Docket Number:	18-IRP-01
Project Title:	Integrated Resource Plan
TN #:	230855
Document Title:	Staff Report - Review of Glendale Water and Power's 2019 Integrated Resource Plan
Description:	N/A
Filer:	Courtney Wagner
Organization:	California Energy Commission
Submitter Role:	Commission Staff
Submission Date:	11/26/2019 8:27:42 AM
Docketed Date:	11/26/2019

STAFF REPORT

Review of Glendale Water and Power's 2019 Integrated Resource Plan

Figure 2: Glendale and CEC Peak Forecasts 2019-2030 (MW)

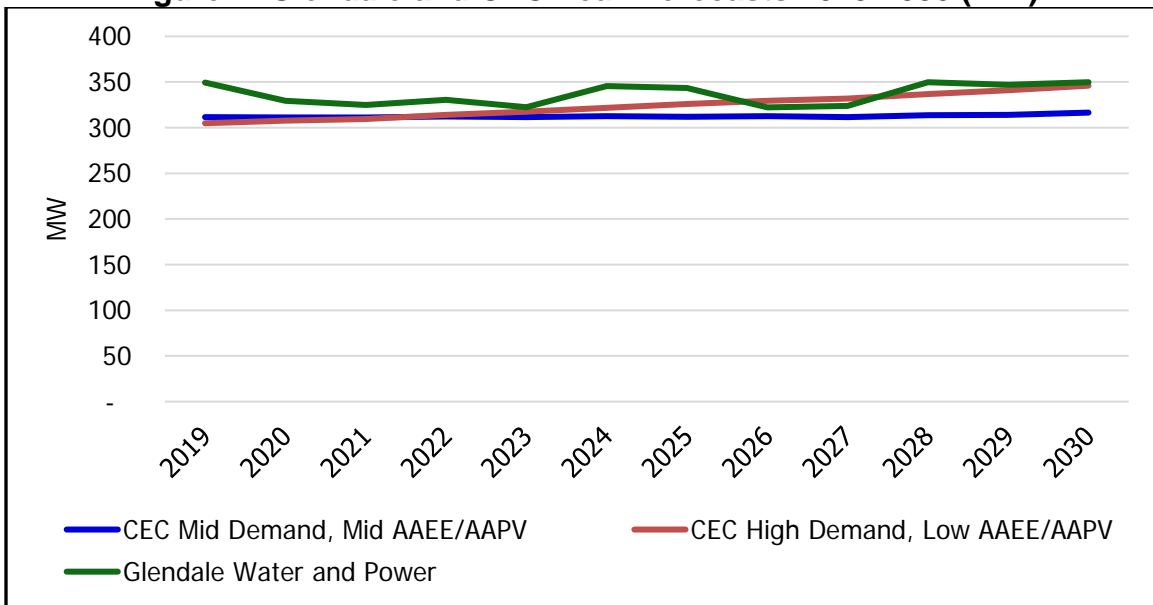
As can be seen in **Figure 2**, the forecasted peak demand is typically above the *2018 IEPR Update* high-demand, low-AAEE/AAPV forecast. This is likely due to a difference in assumed load shape.
